ADDENDUM NO. 1

PROJECT NAME: NEBRASKA SOCCER & TENNIS COMPLEX - SOCCER FIELD
UNL PROJECT NUMBER: C909P101
BID INVITATION NUMBER: 2268-13-7200

CONSULTANT: OLSSON ASSOCIATES, INC.
ADDRESS: 1111 LINCOLN MALL, SUITE 111, LINCOLN, NE 68508

DATE OF ISSUANCE: WEDNESDAY, NOVEMBER 20, 2013
DATE OF BID OPENING: TUESDAY, NOVEMBER 26, 2013

REVISED LAYOUT PLAN

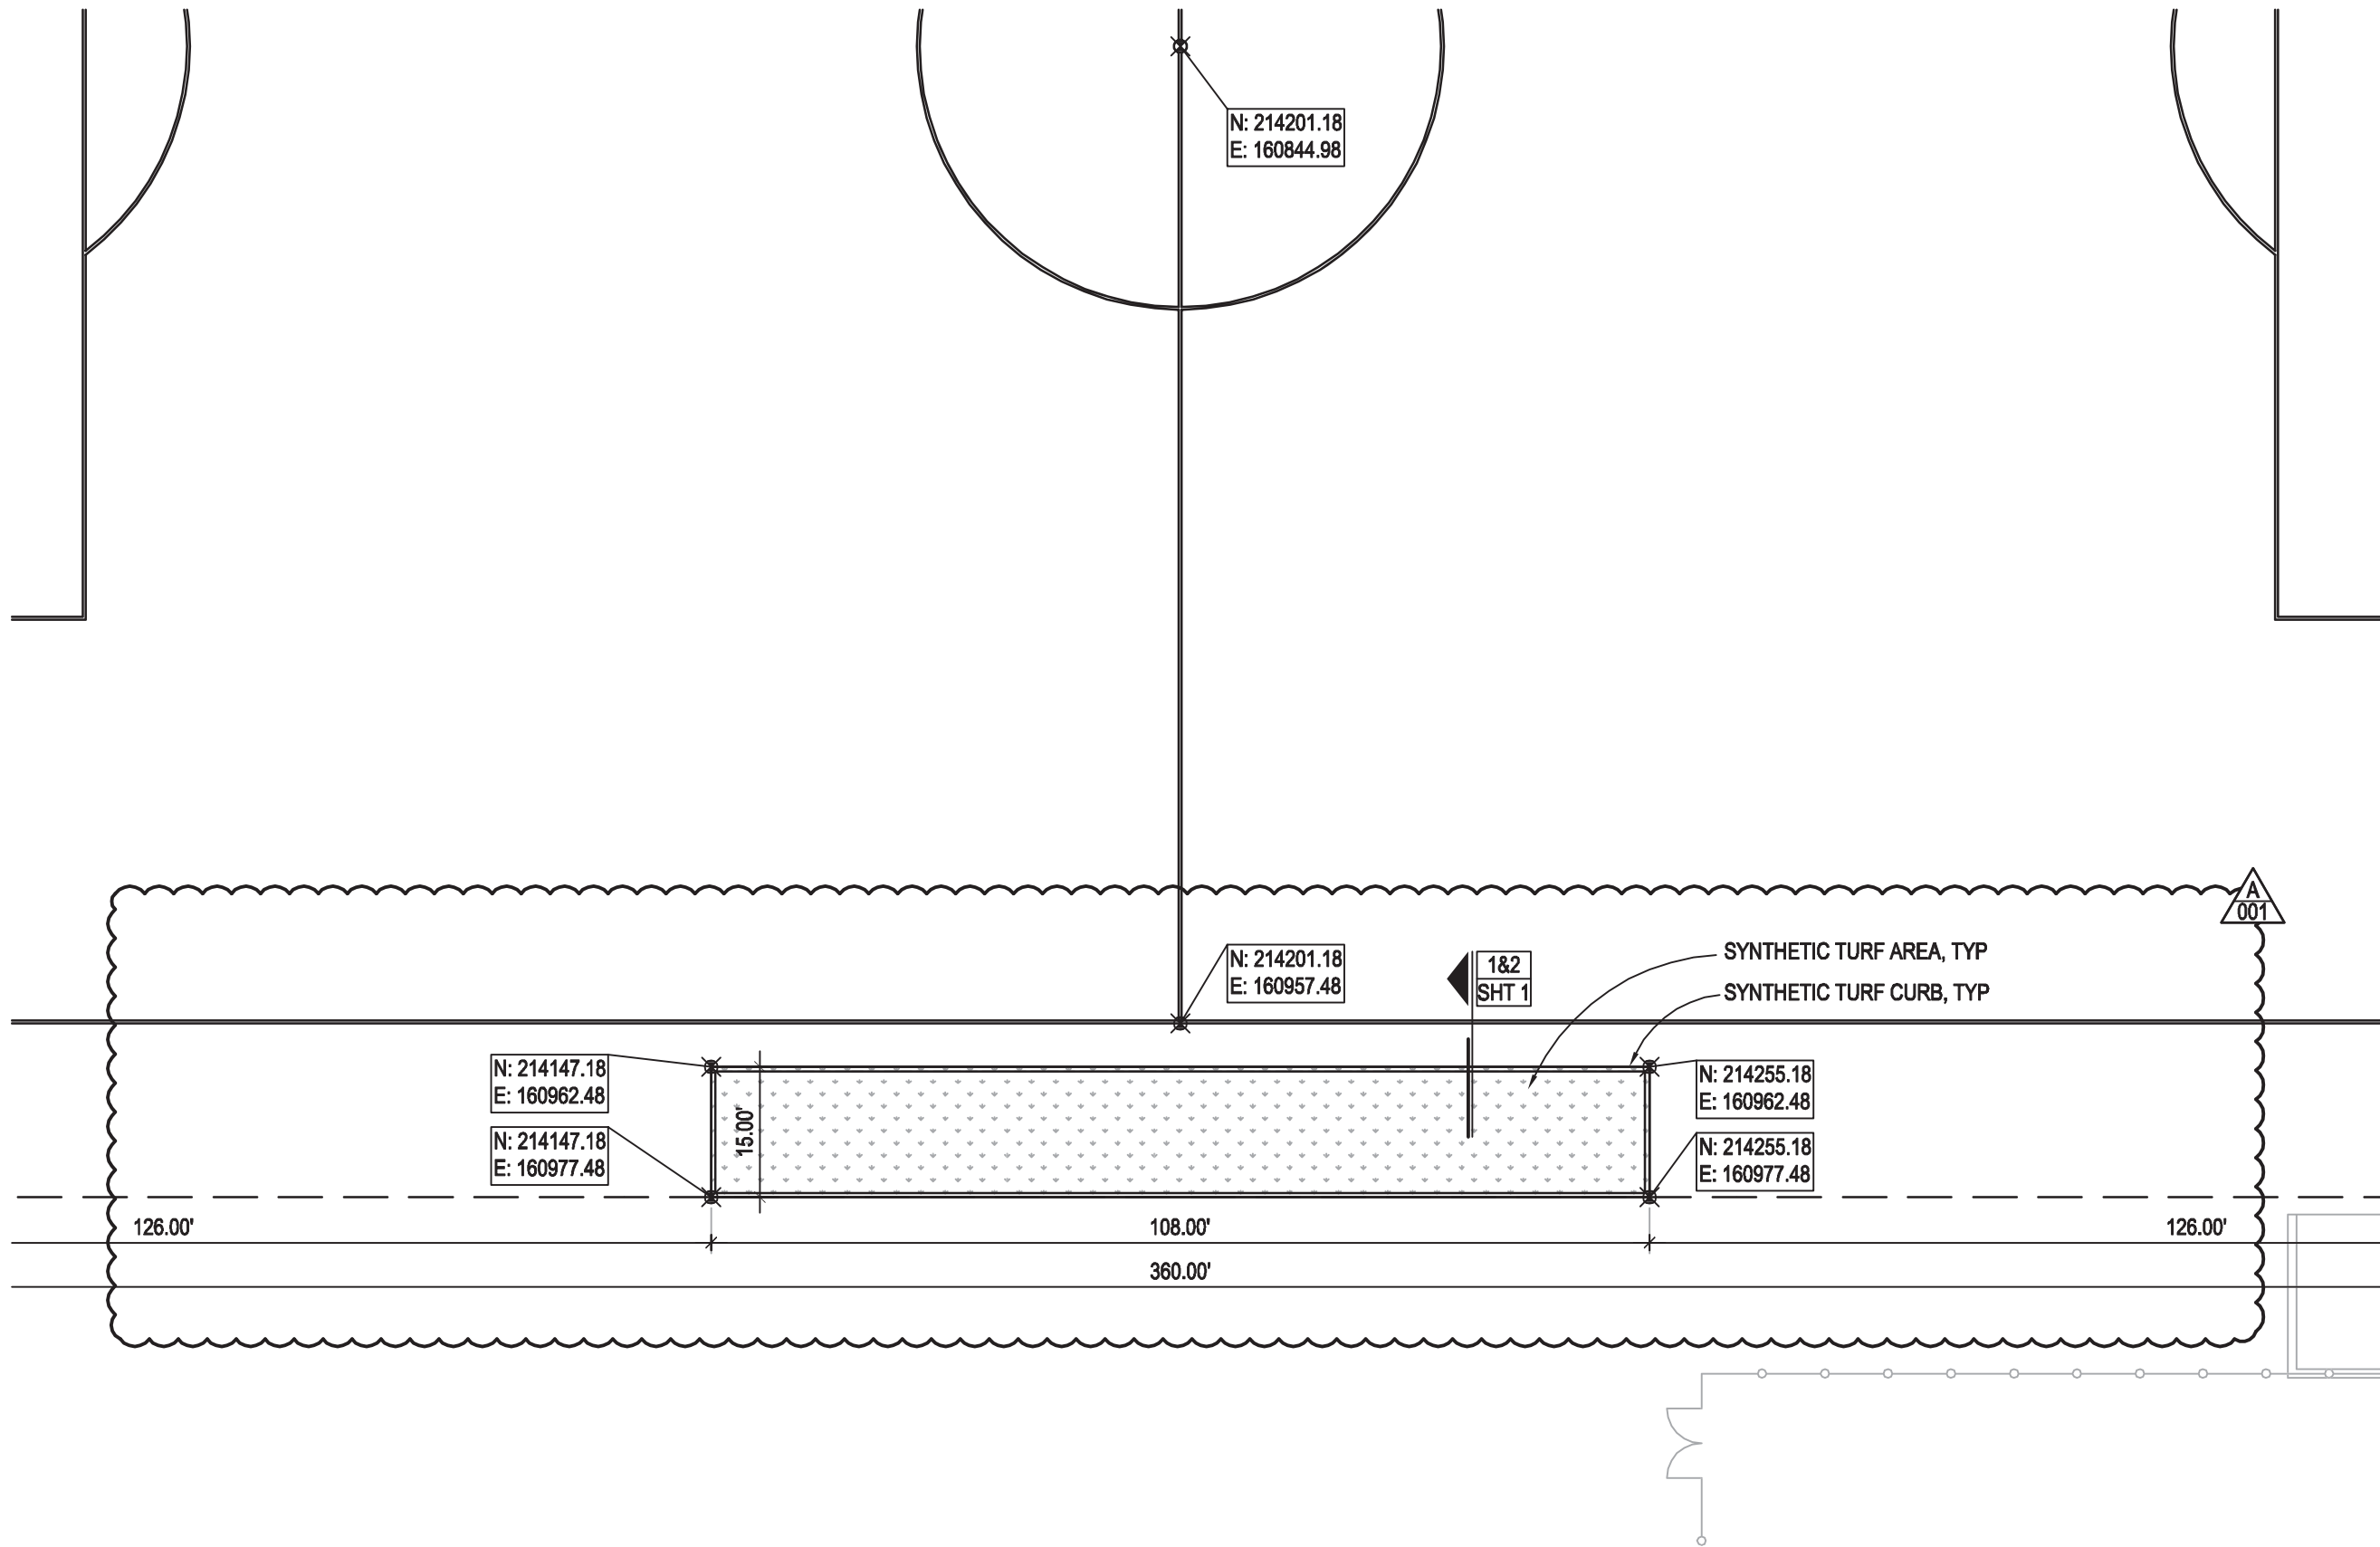
1. Replace temporary protection note on drawing to read: "Provide a temporary fence around perimeter of soccer field for protection. Future Building Contractor will remove the temporary fence."
2. Refer to Drawing No. SDL01 and SDL02 for additional requirements of adding a synthetic turf area to the project

SYNTHETIC CURB DETAIL

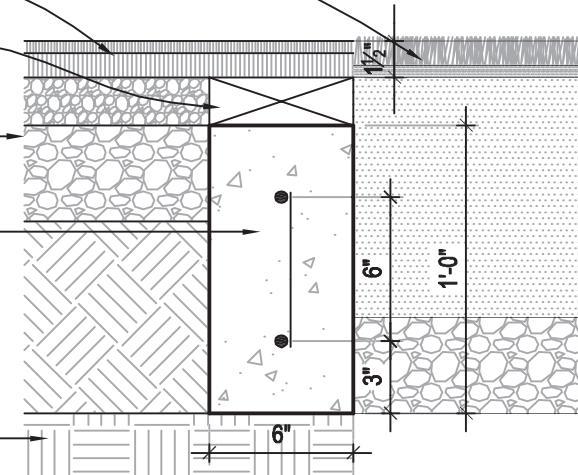
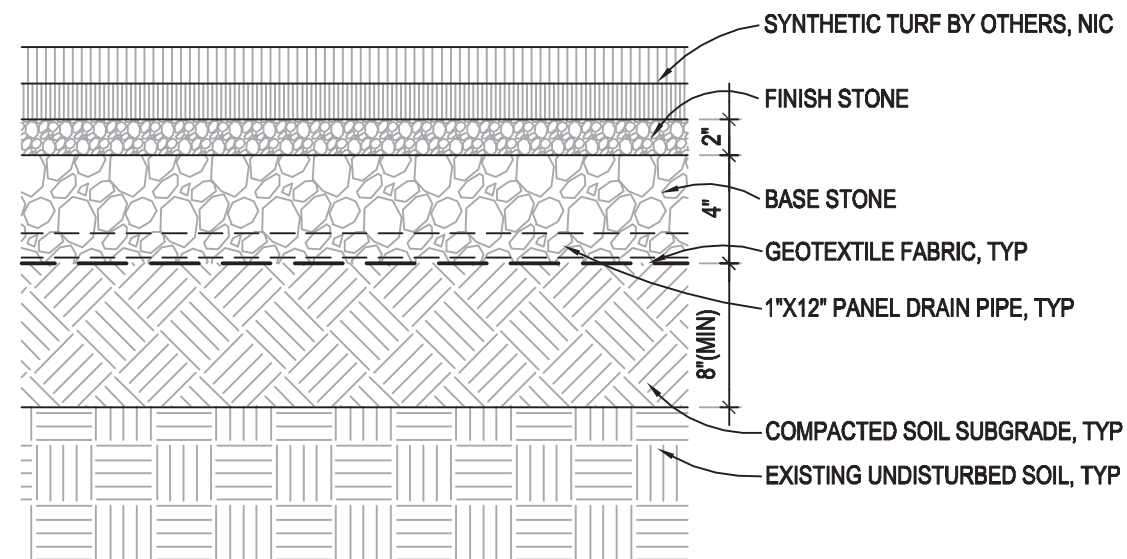
2x6 TREATED WOOD NAILER BOARD,
FASTEN TO CONCRETE, TYP

6"x12" CONC CURB W/ #4 BAR TOP
AND BTM, SPACE AT 18" O.C., TYP

PROVIDE VERT BARS AS REQUIRED
TO TIE HORZ INTO PLACE, MAINTAIN
MIN COVERS AS REQUIRED, TYP

REVISED GRADING PLAN

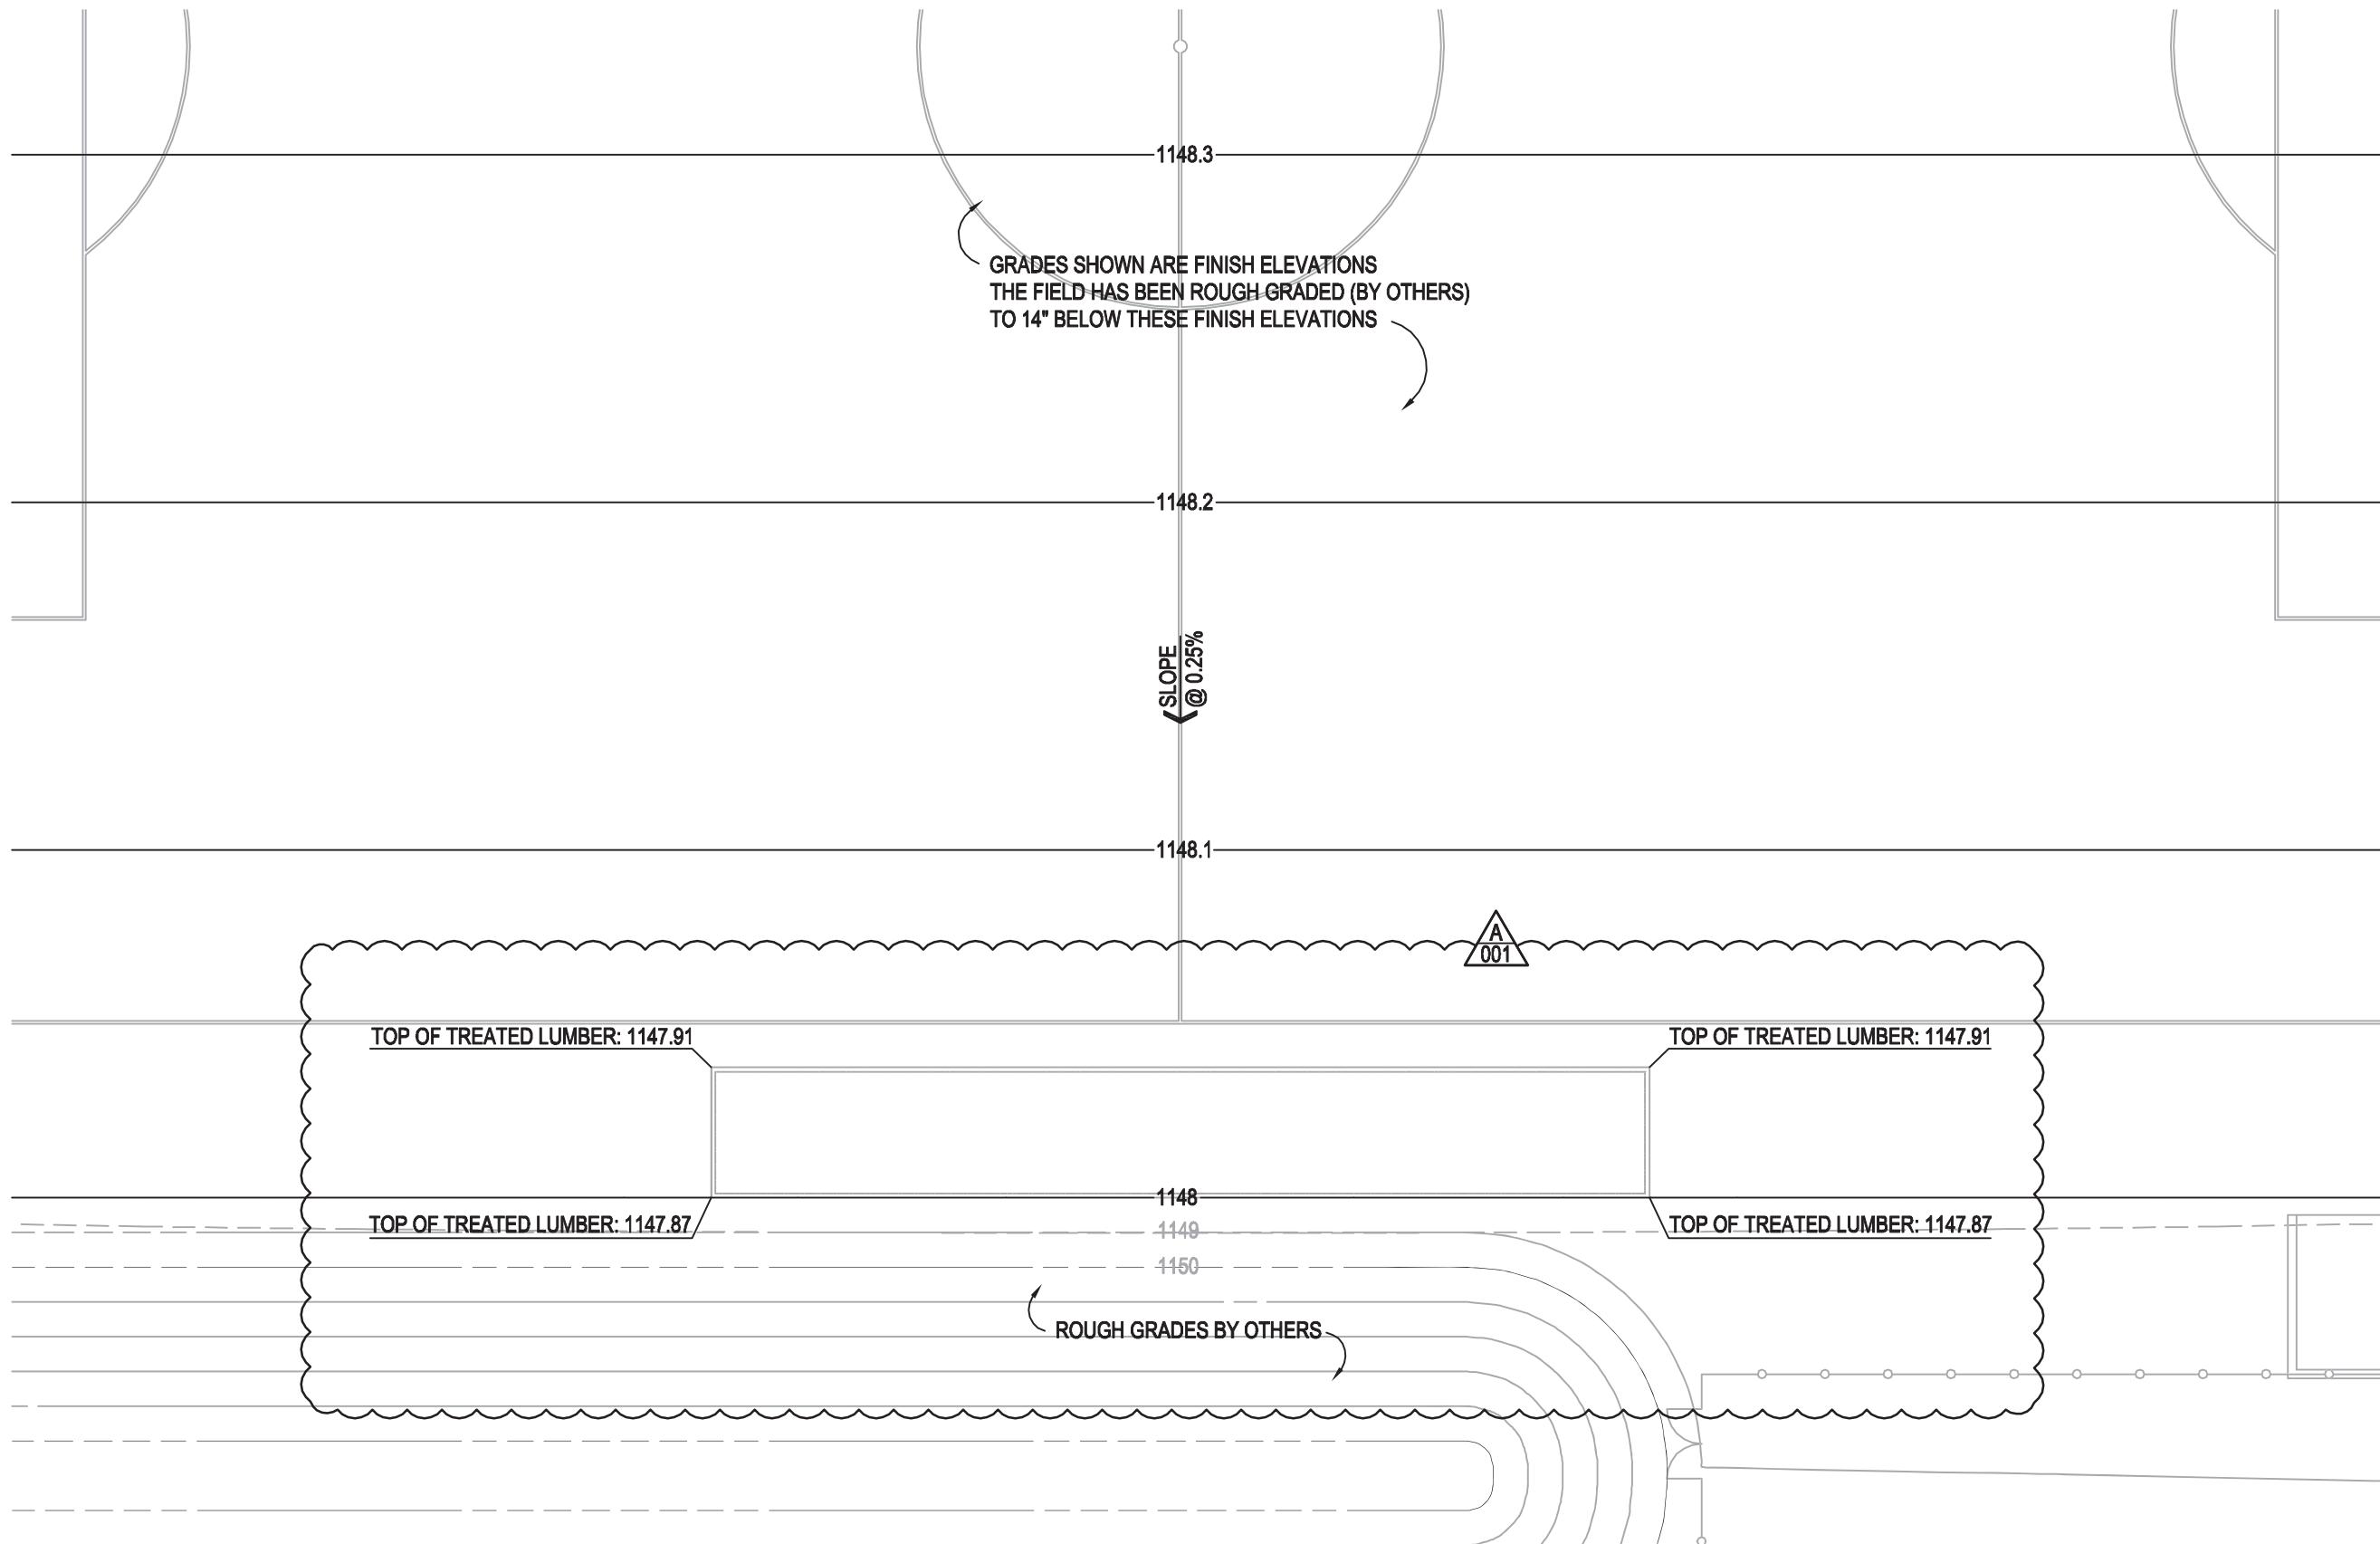
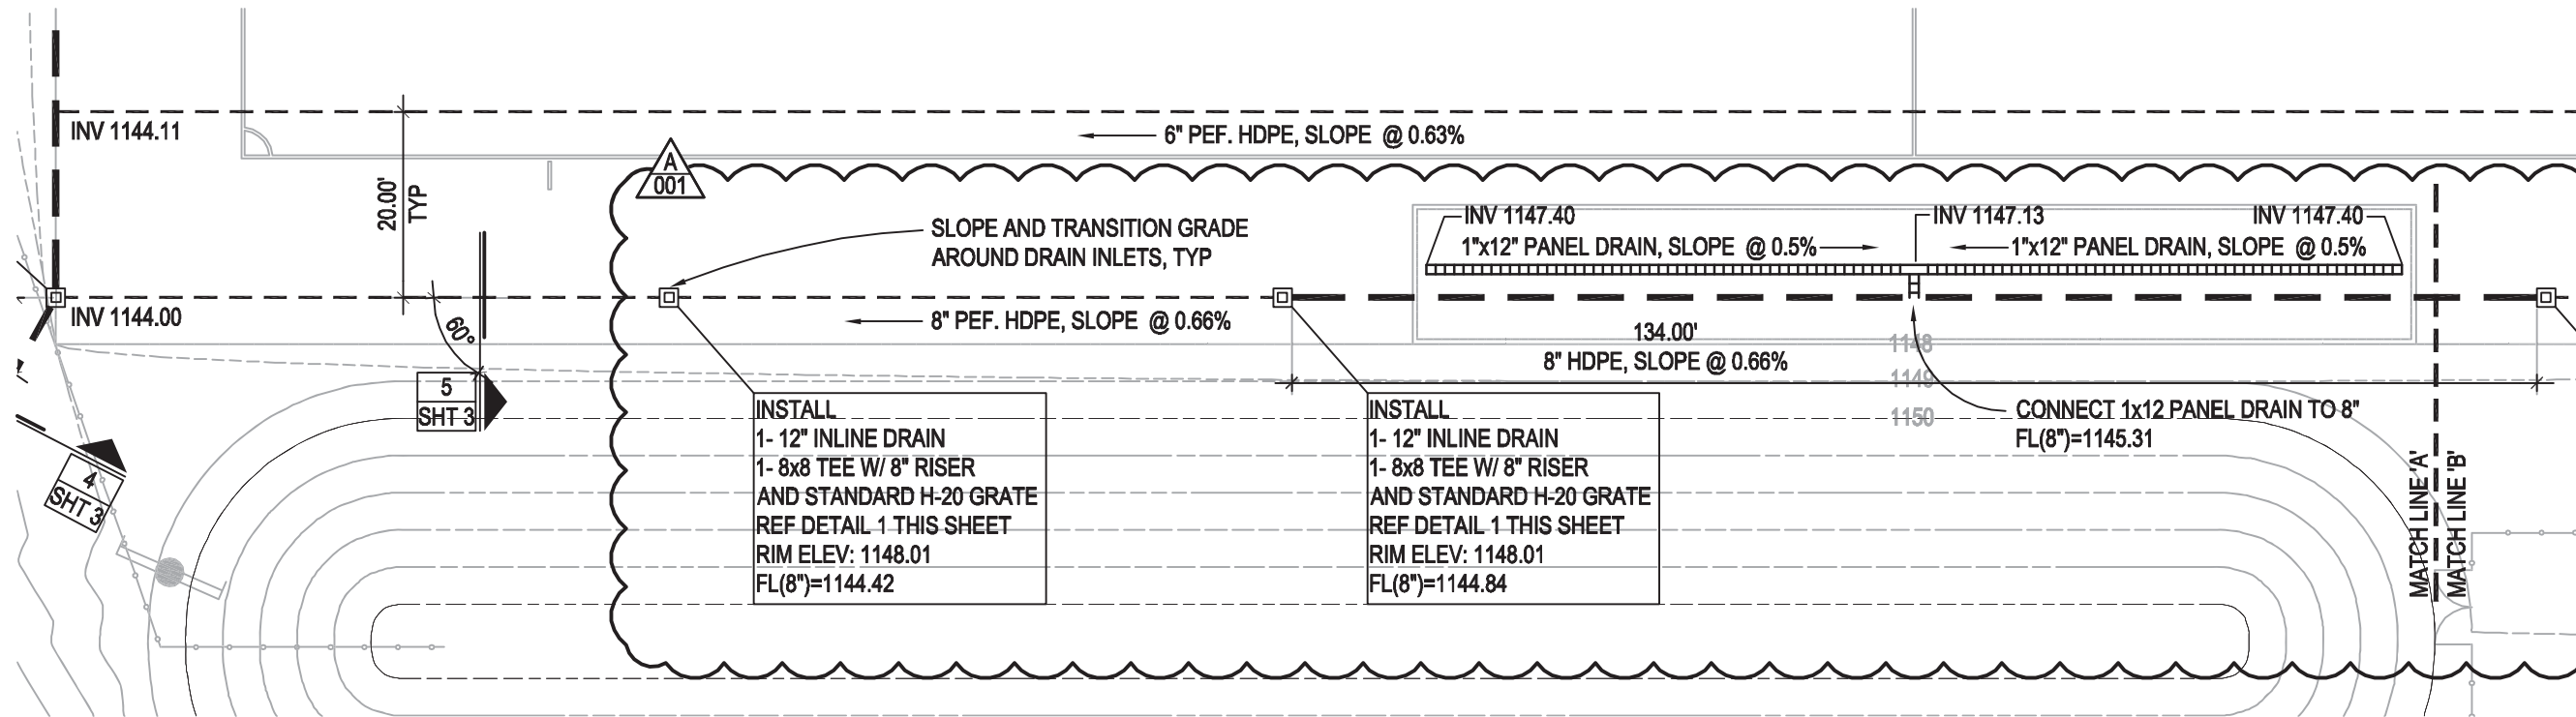
1. Refer to Drawing No. SDL03 for additional spot elevations around the synthetic turf area
